**ADDENDUM NO. 1**

**TOWN OF BRIDGEWATER  
ELM STREET RECONSTRUCTION PROJECT**

**BIDDER QUESTIONS**

BRIDGEWATER  
ELM STREET  
CONSTRUCTION PLAN & PROFILE  
SHEET 08 OF 65

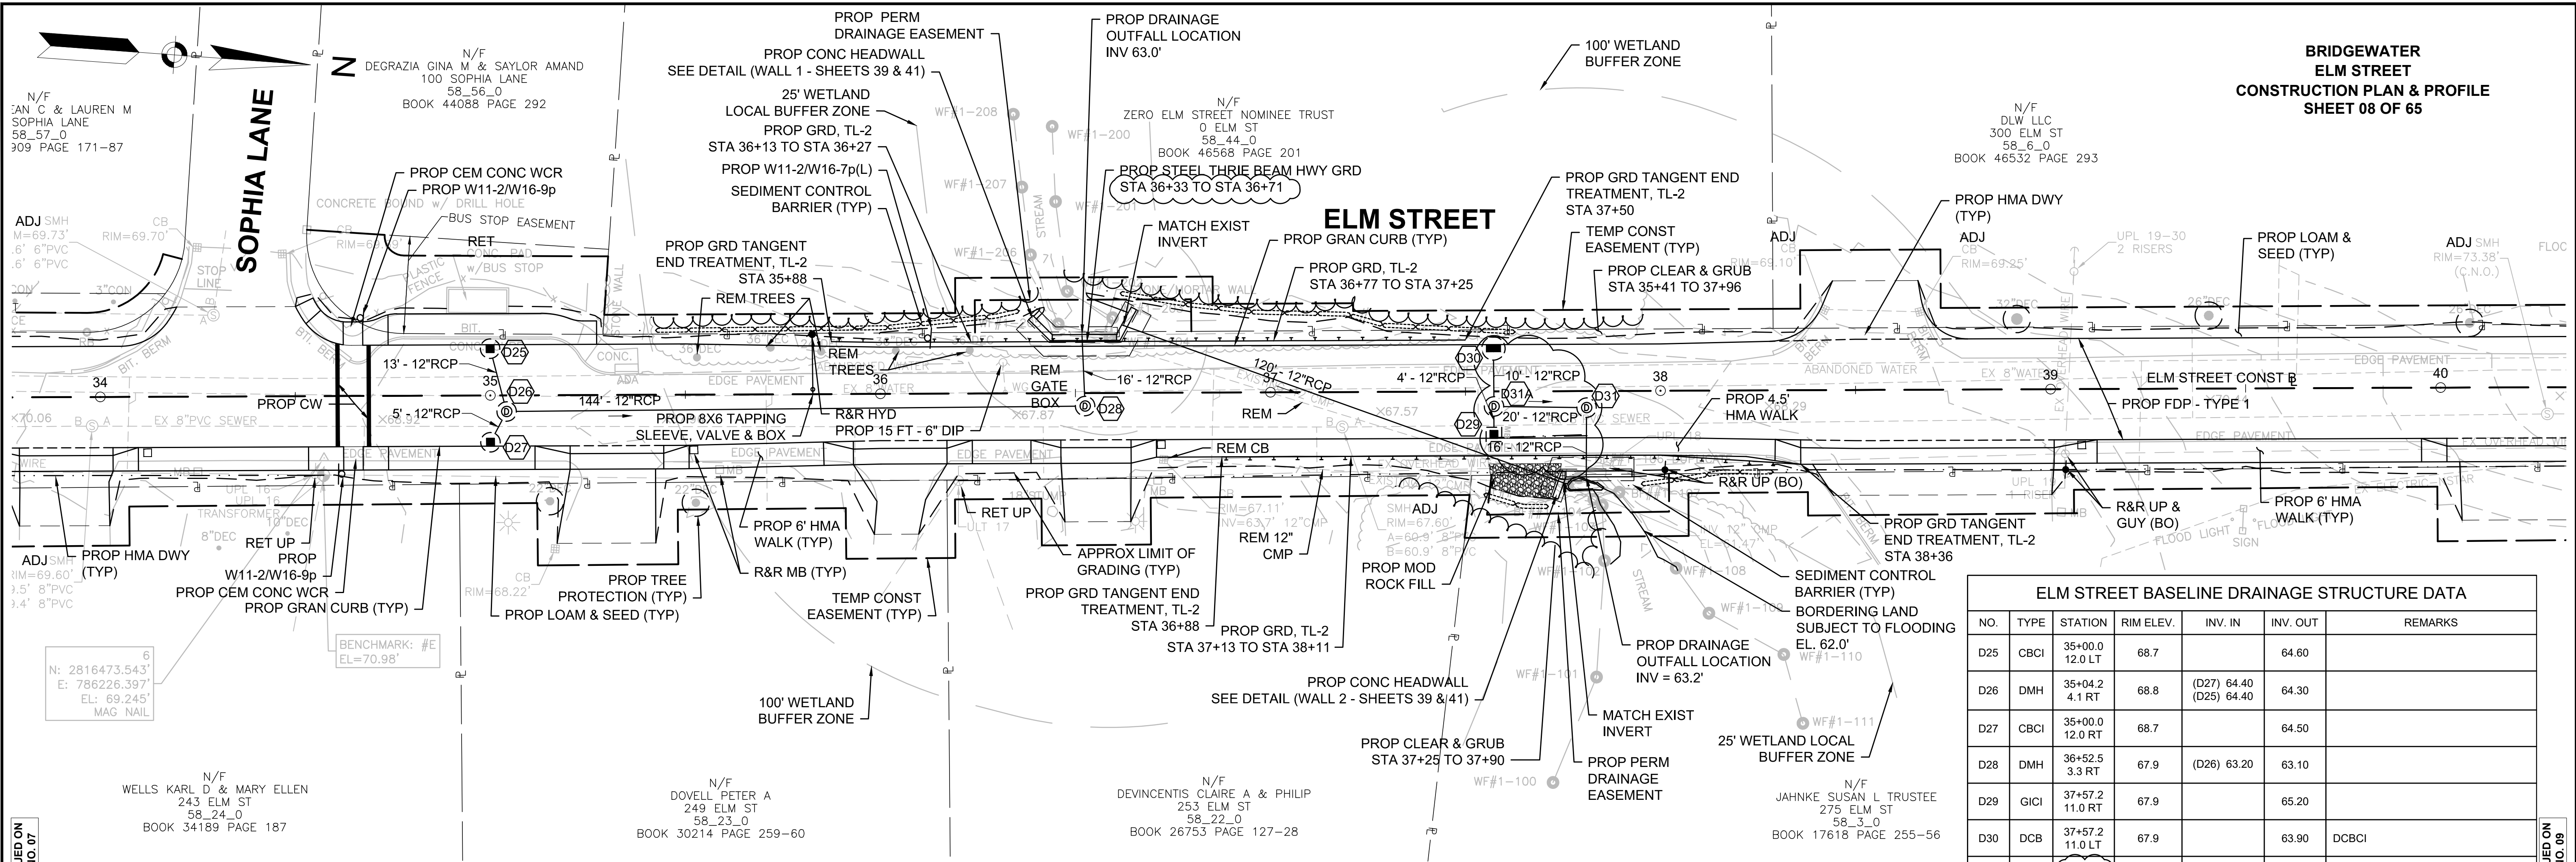
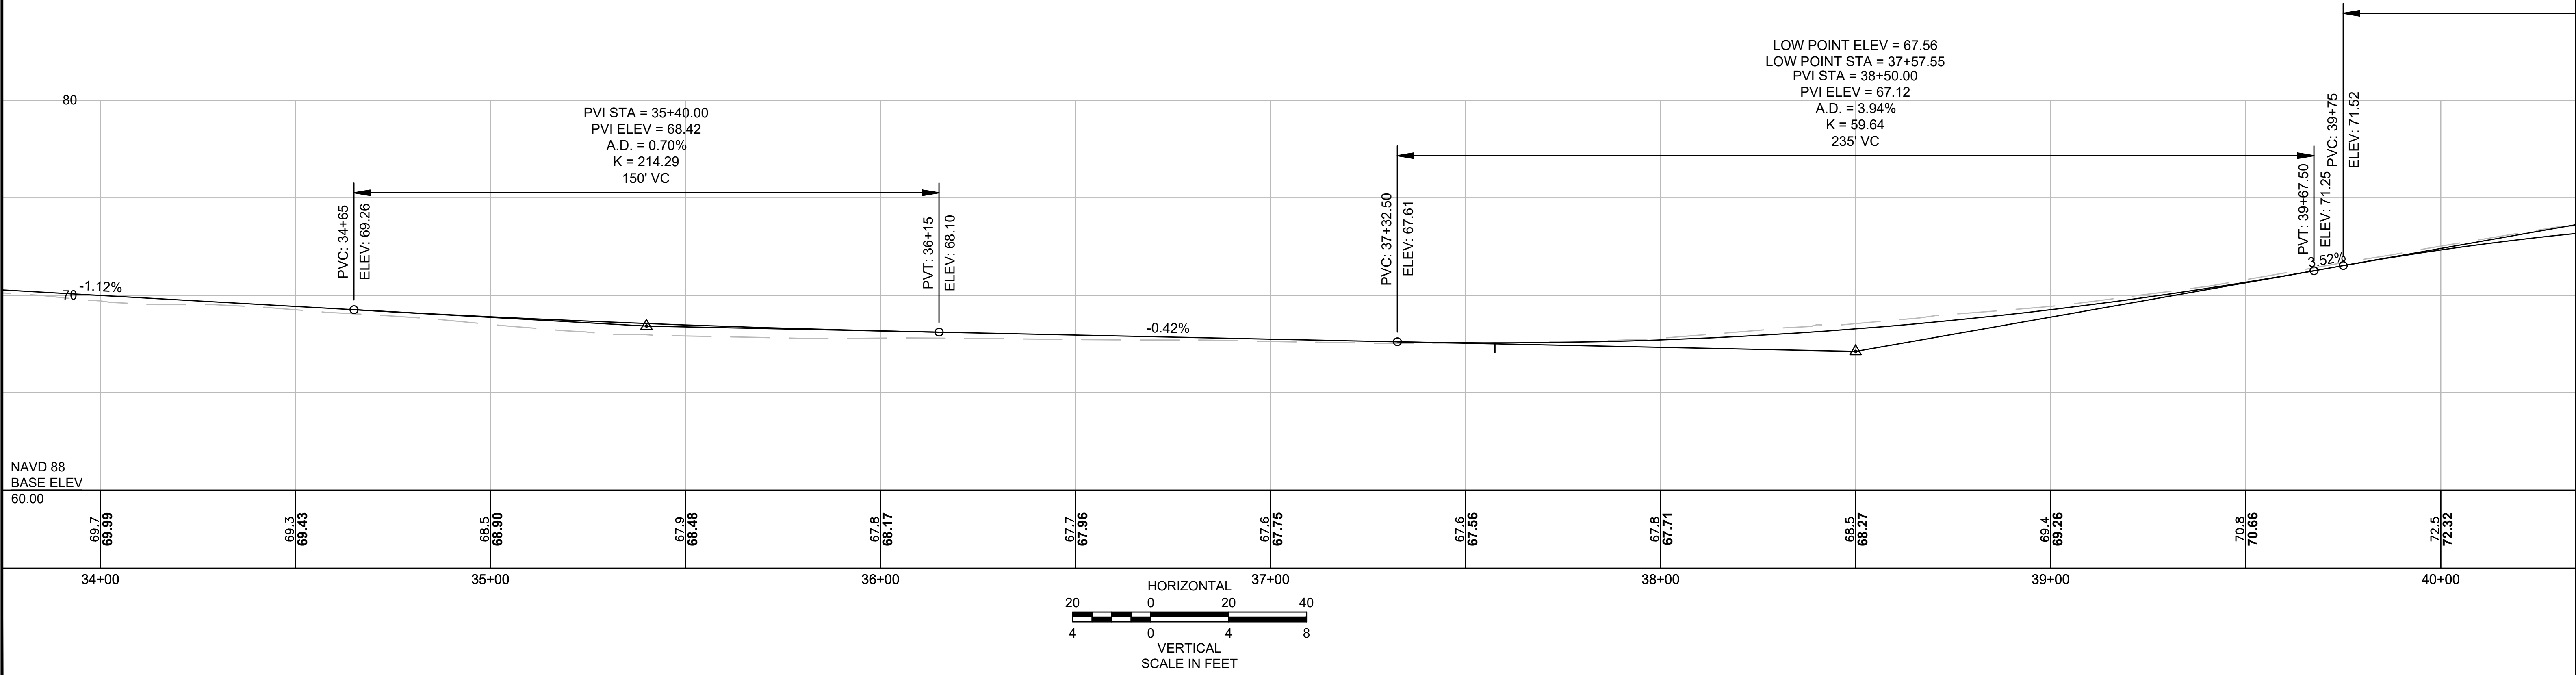
14. Sheet 8:

- a. There is no information for drainage structure D31a in the Drainage Structure Data Table. Can you please provide?

- b. Can the stationing of the different types of guardrail sections be confirmed?

- c. What are the limits of the modified rockfill to be placed around Headwall 2?

**Answer: A revised plan is attached with this missing information.**

**Answer: The stationing was reviewed. There is a mislabeled section of highway guard between station 35+88 and 37+50, left. The plan labels have been corrected and are included in the revised sheet. The stationing of the other guard rail locations is confirmed.**

**Answer: The limits of the modified rockfill have been added to the plans. Refer to the attached revised plan.**
